**GUJARAT NRE NO.1 COLLIERY MAJOR
EXPANSION PROJECT PART 3A
APPLICATION**

Preferred Project Groundwater Assessment

26 November 2013

Figure 1. Comparison of previous and current mine plans for Wonga East. Current mine plan sourced from Gujarat (2013) and overlaid with georeferenced information from Coffey (2013). Comparison of Panel Layouts for Wonga East.

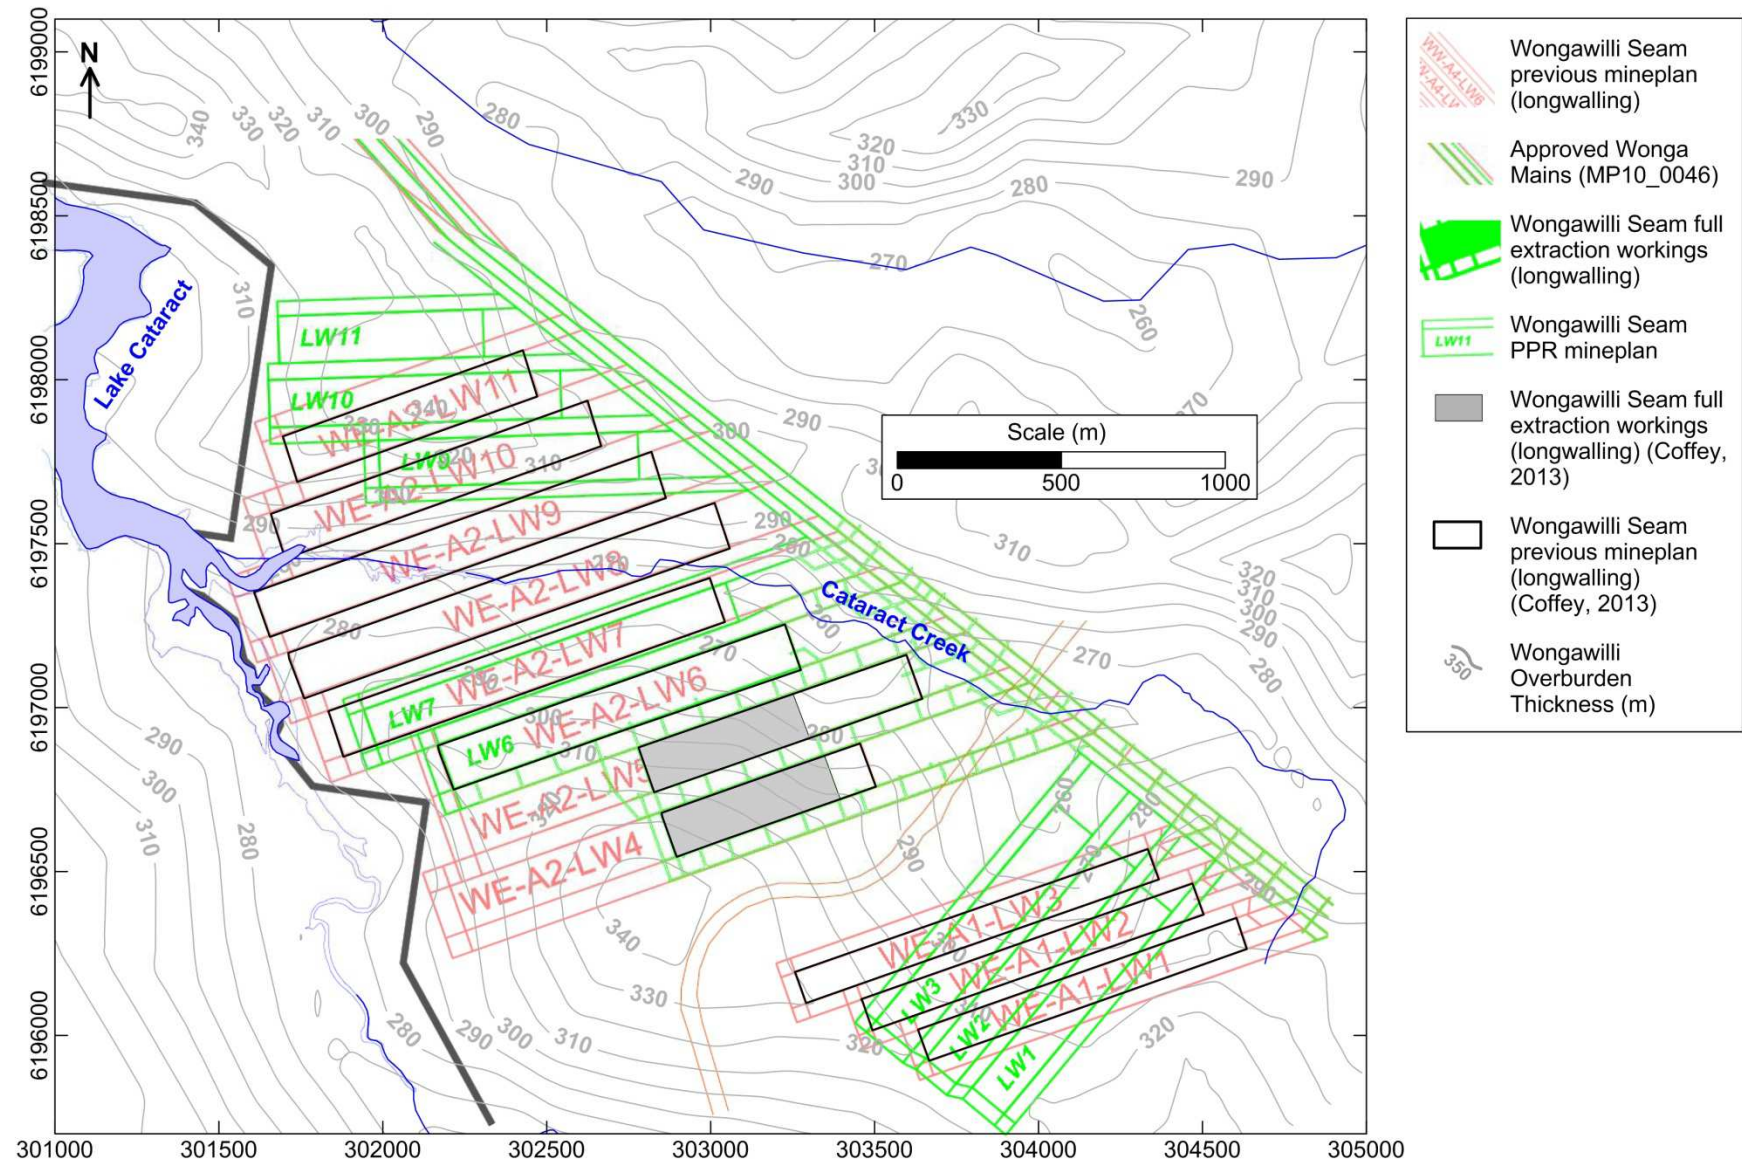
The new mine plan is presented in Figure 4 of the PPR however no scale is shown and it is not georeferenced. This mine plan was positioned with respect to the MGA by overlaying the EA and PPR mine plans of Figure 4 of the PPR onto a georeferenced drawing of the EA mine plan, and scaling it until a visual match was obtained between the two versions of the EA mine plan. The result is shown in Figure 1. This process allowed positioning of Cataract Creek (not shown in Figure 4 of the PPR) with respect to LW7 of the PPR mine plan. However, the positioning error from this process is unknown.

The new layout of LW7 (Figure 1) is still considered to pose a risk to the capacity of the channel of Cataract Creek to transmit surface water. A significant element of the risk is demonstrated by the indication provided by subsidence monitoring of Balgownie and Wongawilli Seam panels in Wonga East as discussed in the PPR. Incremental Balgownie panel subsidence ranged between 0.9m and 1.2m where overlying Bulli goaf (room and pillar panels with pillar extraction) was present, approaching 80% of the mined height (implying a mined height of about 1.5m for the Balgownie panels). In unusual areas (latent subsidence, goaf edge), the incremental subsidence reached 1.4m, approaching 100% of the mined height. Figure 2a (after Figure 49 of the PPR) shows these results.

Where the top of a collapsed zone is some distance below the surface, the surface disturbance at a channel bed may not be strongly hydraulically linked to the collapsed zone. In the case of LW7, there is considered to be a risk of direct hydraulic connection between the creek channel and goaf, through the collapsed zone, where the channel comes close to the panel edge. The level of risk is difficult

to quantify but warrants consideration. Monitoring of groundwater response and ground deformation in this area during the early stages of LW7 retreat may be useful in better informing the risk.

Figure 2. Subsidence monitoring results for the (a) Balgownie and (b) Wongawilli panels at Wonga East (after Figures 49 and 58 of the PPR).

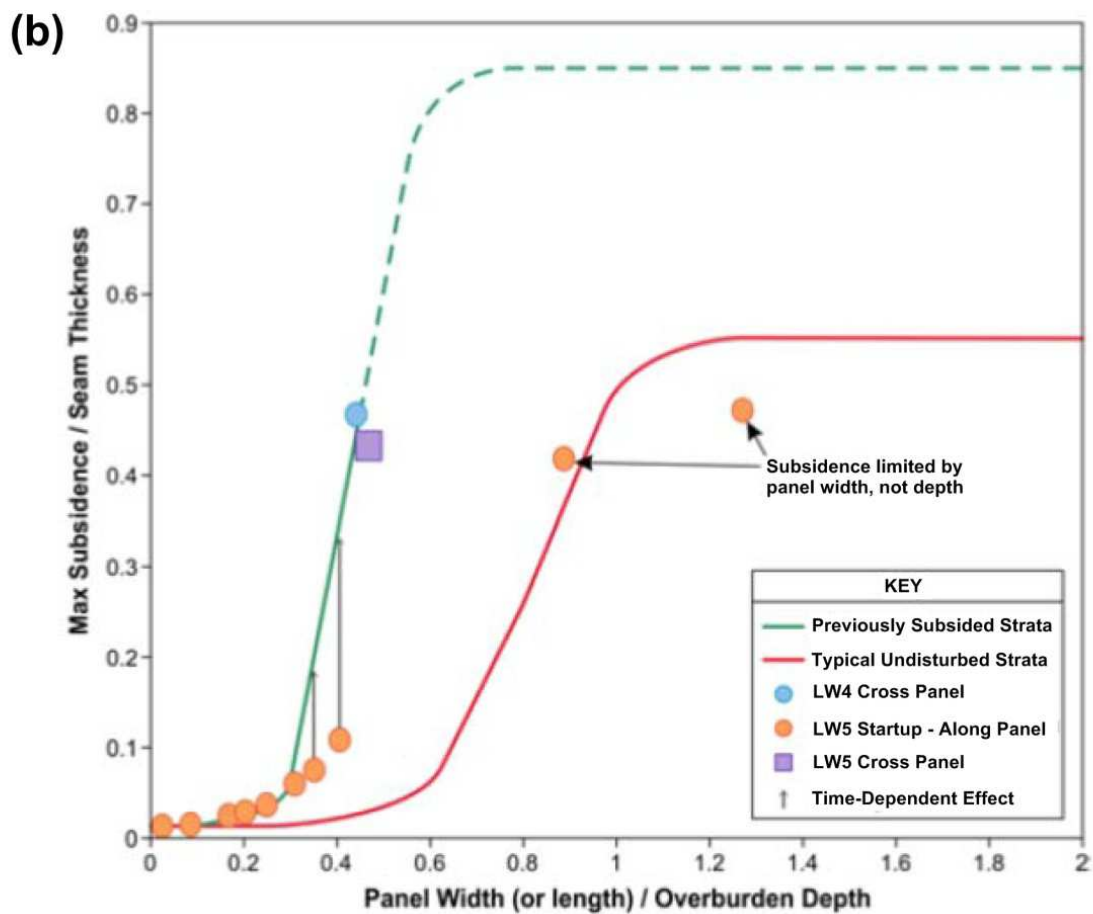
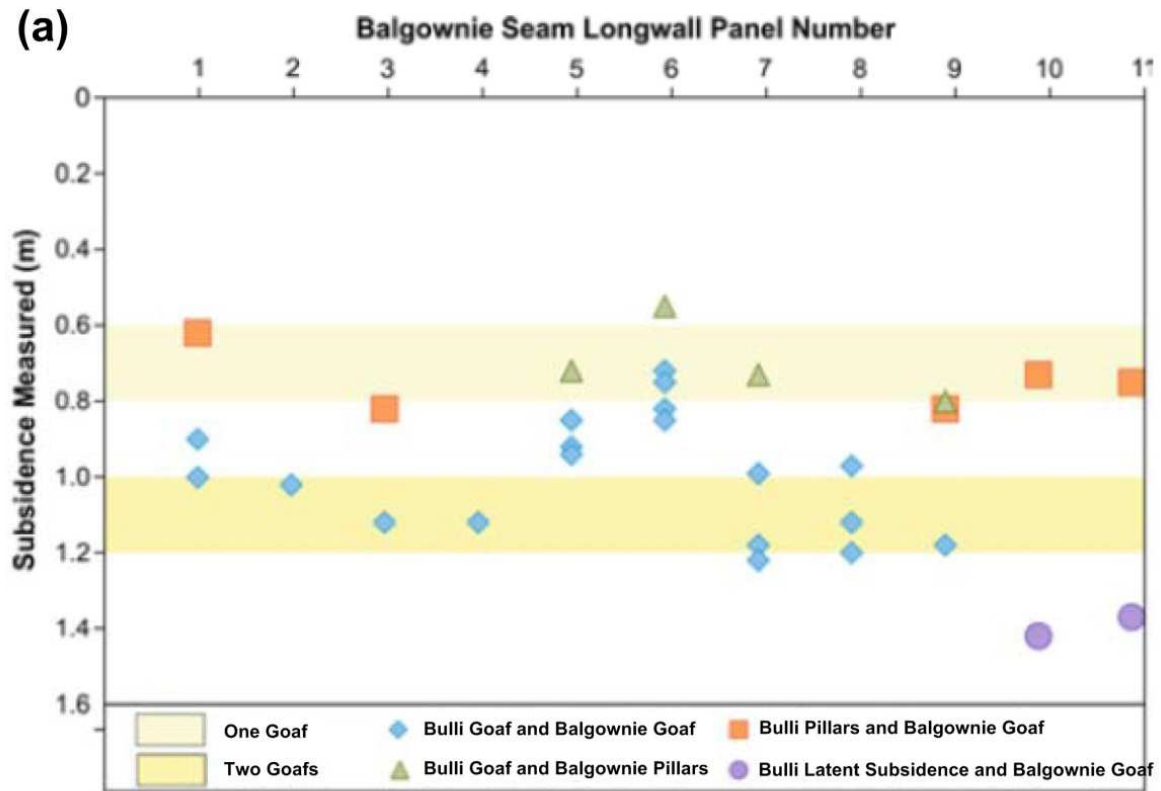
Maximum incremental subsidence at Wongawilli LW4 was 1.4m. For the mining geometry of LW4, and assuming single seam mining, surface subsidence would be expected to range between 0.1m and 0.3m, about 14% of the observed subsidence where Balgownie and Bulli goafs are present. The PPR states that cross panel subsidence profiles indicate that the maximum subsidence in the centre of the Wongawilli panels is controlled by overburden bridging capacity rather than strata recompression. The presence of overlying goafs reduces the bridging capacity of overlying strata, having a significant effect on maximum incremental subsidence for the Wongawilli panels. It was also observed that the additional subsidence was confined to the panel footprint. Figure 2b (after Figure 58 of the PPR) shows these results.

Although a relationship between surface subsidence and the height of desaturation (H) is unavailable (due to the significantly greater dependence of surface subsidence on overburden depth compared to H), these results indicate that there is a high likelihood that the height of H for a Wongawilli panel will be larger than that calculated using the relationship for single seam mining (Tammetta, 2012). Since the LW7 width has only been reduced by 19m (about 13% of the original width), it is reasonable to conservatively assume that the height of the collapsed zone (H) intersects the ground surface at the northern corner of LW7. The minimum separation distance between the LW7 collapsed zone and the Cataract Creek channel centreline is approximately 45m (at the northern corner of LW7, see Figure 1). The positioning of the new mine plan is approximate (see above) and the channel centreline was digitised from information in Geoterra (2012a, 2012b) and ERM (2013) (see Coffey, 2013).

Figure 3. Estimated angle of hydraulic head influence for longwall panels (after Ouyang and Elsworth, 1993).

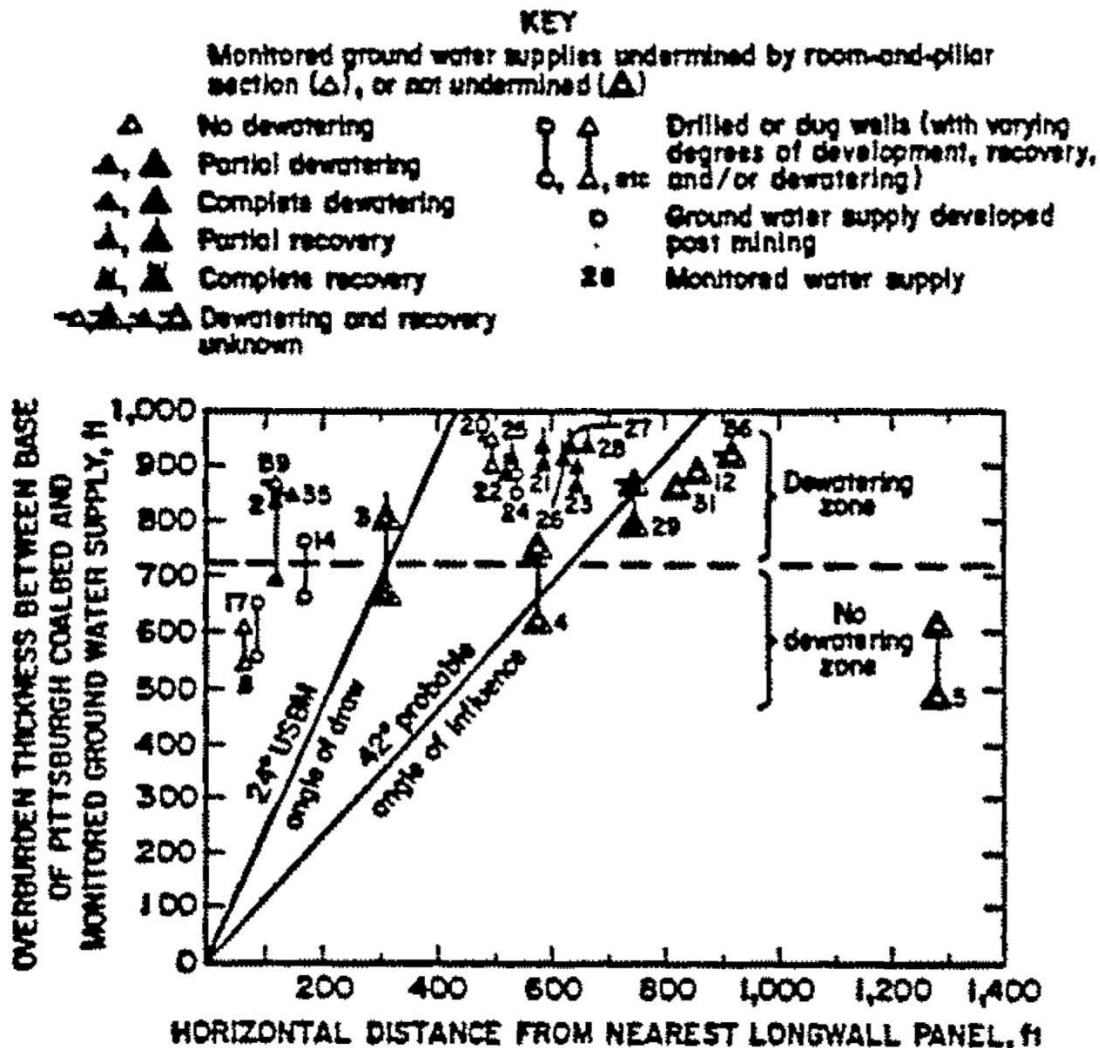
Ouyang and Elsworth (1993) estimated a probable angle of influence (defined as the angle whose tangent is the lateral distance to an impact at the surface, divided by the overburden thickness) of 42° from 39 off-panel wells (Figure 3). Cifelli and Rauch (1986) estimated an average angle of influence of about 20°, with several observations of impact outside this angle. The Australian Federal Government (2013) estimated a maximum angle of influence for impacts to peat swamps of approximately 45°. These impacts were characterised by deformation of the rock underneath the swamp.

The overburden thickness at the northern corner of LW7 is approximately 260m, so that the creek channel falls within interpreted zones of impacts to hydraulic heads from longwall mining. Using 45° as an upper limit, the angle of influence would extend surface impacts to a distance of about 260m from the boundary of LW7 in the vicinity of its northern corner. This estimate does not include the effects of multiple mined seams, nor the effects of topographic gradients, both of which may alter the zone of influence.

Figure 4. VWP hydrographs for Monitoring Location GW1 (see Coffey, 2013).

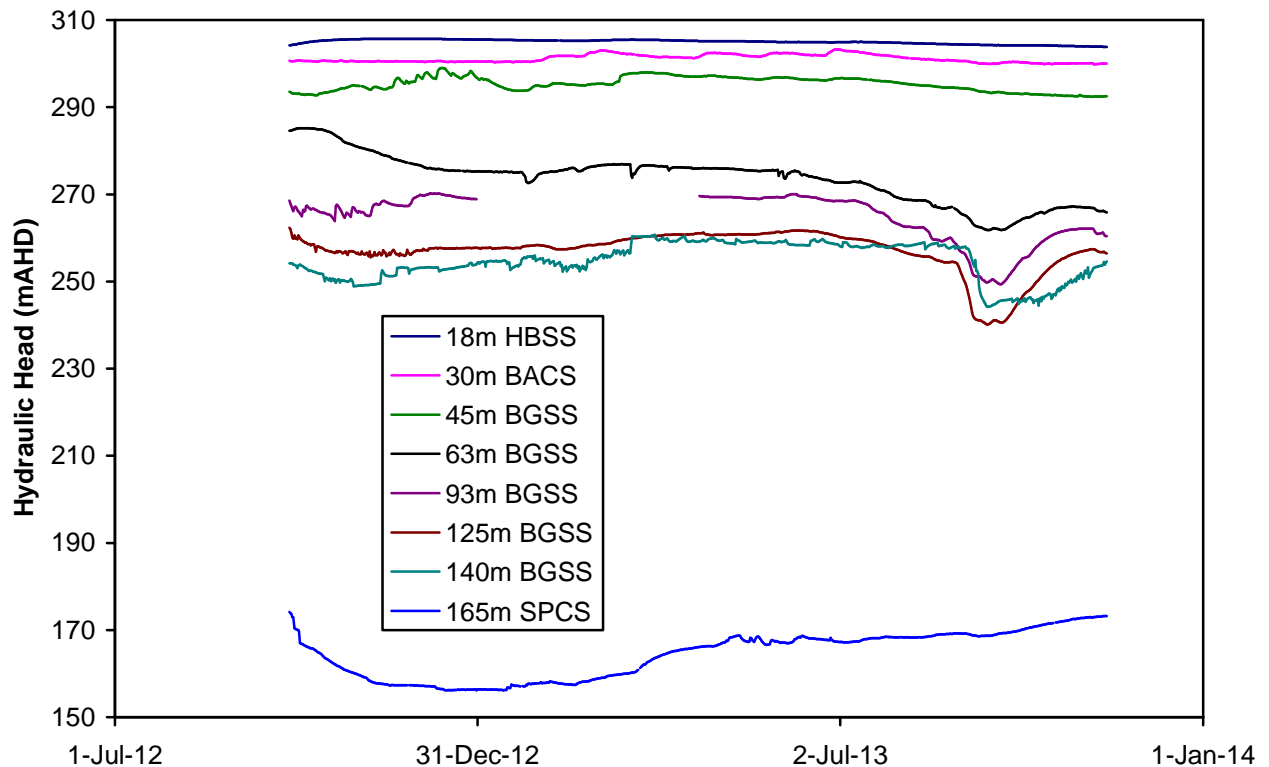
Hydraulic head monitoring data from the vibrating wire piezometer (VWP) nest at GW1 (see Coffey, 2013) were selected by the proponent for collection of near-field drawdown from longwall advance, for the purpose of model calibration. The monitoring data were not presented in the PPR but were supplied by Gujarat by email on 19 November 2013, at the request of the reviewer. Figure 4 shows the supplied data. The key in Figure 4 shows the depth below ground for each VWP, and the lithology at that depth (HBSS, BACS, BGSS, and SPCS denote the Hawkesbury Sandstone, Bald Hill Claystone, Bulgo Sandstone, and Stanwell Park Claystone respectively). The hydrographs for Bulgo Sandstone VWPs capture the effect of depressurisation from LW5 in late 2012. The measured drawdown is considered useful for model calibration of near-field disturbance.
